Installation Instructions:

Wiring Schematic for P-6001-B Paragon Senior Control Assembly

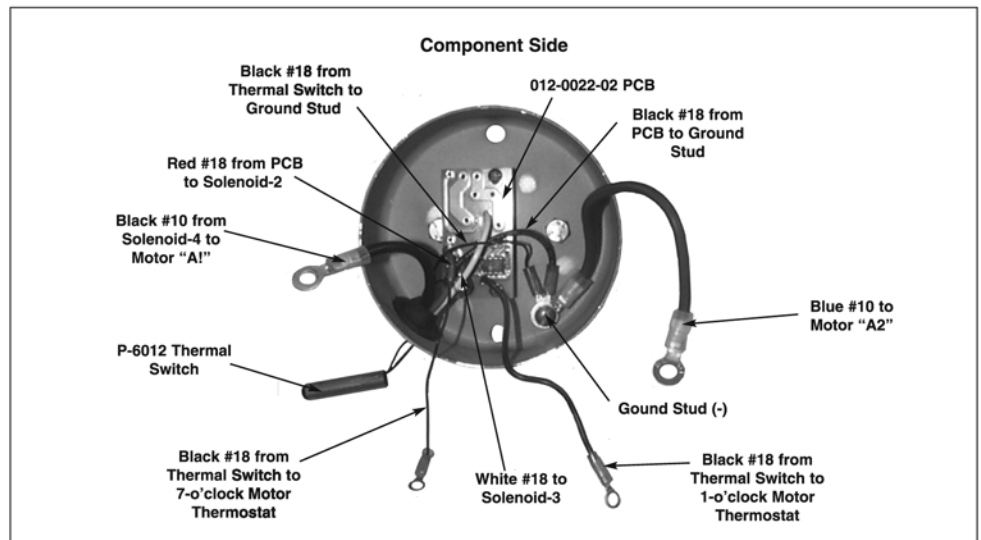
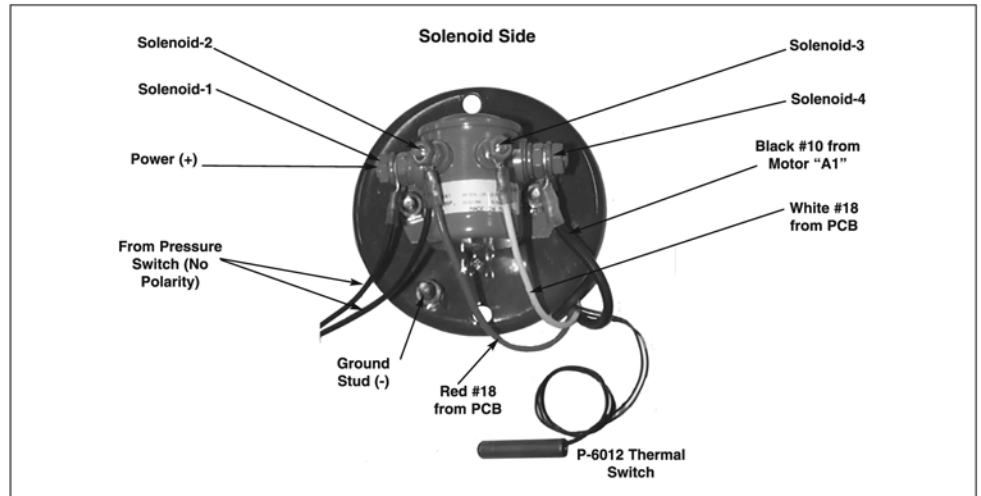
P-6002 (PCB with Thermal Switch) is no longer available; it is replaced by 012-0022-02 PCB, and P-6012 Thermal Switch, sold separately.

012-0022-02 is supplied with ring terminals for use with pumps manufactured after 3/00. Mounting and function are the same, but note that 012-0022-02 and P-6012 Thermal Switch are both connected to the ground stud.

If in your installation you wish to utilize the old Thermal Switch, you must cut the ring terminals off the new PCB and crimp on bullet terminals as instructed and pictured below.

Ensure that the ground stud is properly assembled. The two isolation washers must prevent electrical contact between any connected wire and the metal motor cap.
